DC/20/0614/RM

Land Nw Of Haverhill Anne Sucklings Lane Little Wratting Suffolk

Application for Reserved Matters pursuant to hybrid planning permission SE/09/1283 for Infrastructure comprising of: the internal estate roads, drainage, POS, landscaping, and allotments for Land at North West Haverhill

Comments 5.10.21

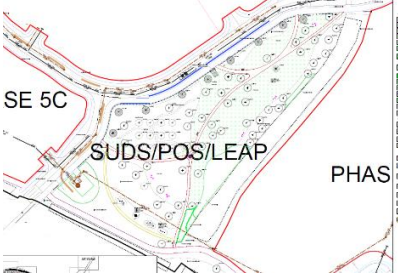
- For all SUDS, move marginal planting away from the head walls to avoid ongoing maintenance liability
- Bat hop planting is required in all locations where the existing hedgerows are dissected to provide roads and accesses (see below)
